CABINET MEMBER FOR HIGHWAY MANAGEMENT – 14 OCTOBER 2021

OXFORD – BOURNE CLOSE - PROPOSED WAITING RESTRICTIONS

Report by Corporate Director, Environment and Place

Annexes	Annex 1: Consultation Plan Annex 2: Consultation responses
Contact Officers:	Tim Shickle 07920 591545

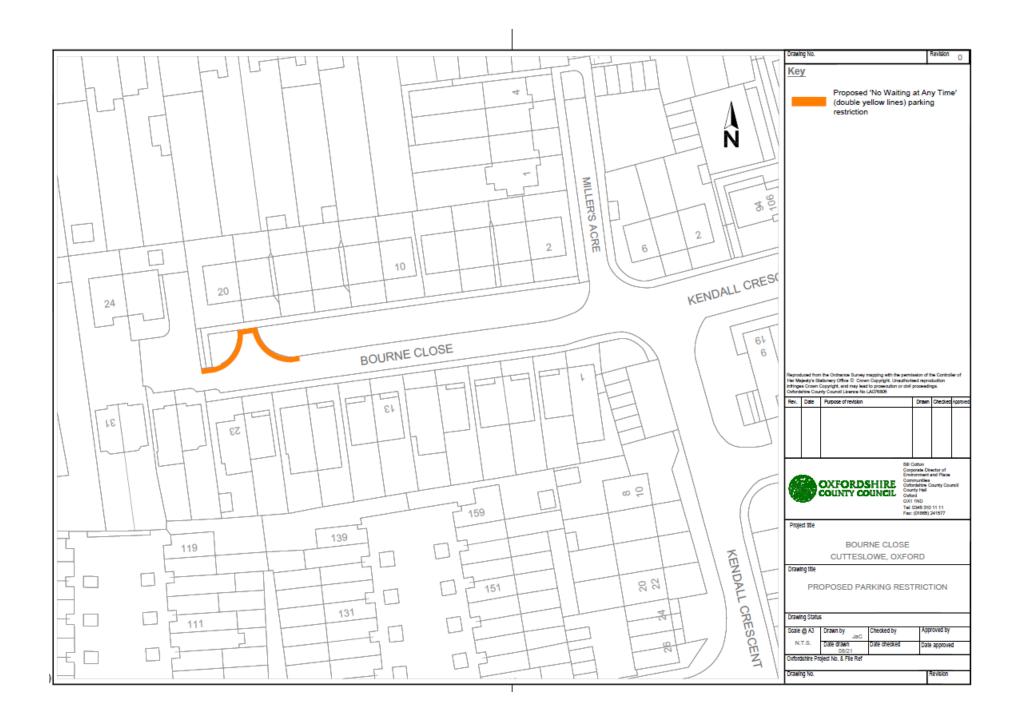
RESPONDENT	COMMENTS
(1) Traffic Management Officer, (Thames Valley Police)	No objection
(2) Local resident (Bourne Close)	Concerns - It would be good to maintain a wide-enough turning area that can be used by delivery vans. There is an increasing number of cars in Bourne Close and the current situation is just about manageable. My suggestions would be to widen the turning area to allow a car to be parked there, while allowing vans to turn. This will reduce the grass a bit but will not impact on the overall feel of the Close; to reduce the length of the double yellow lines coming in to the Close at the southern end; to reduce the length of the disabled bay in the middle of the Close, the current users do not need this much space and it is unclear why they need it as they seem to be well and mobile and also provide indicative parking bays so that space is used optimally, as people have a habit of leaving large gaps.

(3) Local resident (Bourne Close)	Concerns - There is barely enough space for residents to park in Bourne Close as it is, this proposal will only make the available spaces worse. Given the restrictions in the adjacent roads we would not be able to park anywhere near our homes if all the spaces were taken up in the close. I would suggest that new spaces could be created by forming them in the grassed area, thereby allowing the residents the opportunity to park in the Close, whilst freeing up the turning area.

(4) Local resident (Bourne Close)	 Objection – My wife and I strongly object to this change. The issue is that there is not enough parking space for residents, taking the turning area away would mean that sometimes people living in Bourne Close would not be able to park nearby their homes. We cannot park legally in the surrounding area because Bourne Close residents are not part of the parking scheme. Another issue is that we get folk who don't live in the area coming and parking in our street because there are no
	restrictions. Furthermore, some residents are older and less physically able. Not being able to park close to their homes would be a burden. The one disabled parking space we have is already always occupied by a resident. The current state-of-affairs works. Just. The proposed change would cause a lot of problems: more than the problem we sometimes have in turning our cars around.

(5) Local resident (Bourne Close)	 Concerns - While painting double yellow lines on the turning space allows emergency vehicles to turn and protects the private estate at the end of the Close from turning vehicles, it does not solve the parking problems in the Close. It exacerbates them. As I pointed out before, there are fifteen parking spaces at a pinch and twenty-two dwellings on the Close, not counting the additional six dwellings on the private estate who may have visitors who wish to park on the Close. Two of the ten council bungalows are only occupied in theory as the residents appear to live elsewhere. If they return to live on the Close, they both own cars and our parking problems will be even worse. As I suggested before we need extra parking space and I wonder if a small part of the pleasant grassy area on one side of the road could be cleared and paved either at the top or bottom of the road. I do hope the Council can help us out here.

(6) Local resident (Bourne Close)	Concerns - As long as Resident don't need to have parking permit. Restrictions should be for near the curve for turning and nowhere else.

- 10. Balancing the demand for parking and the need to keep the turning area clear it is recommended that the proposals are approved and that at the next review of the Cutteslowe CPZ, consideration is given to consulting on the inclusion of Bourne Close within the scheme.
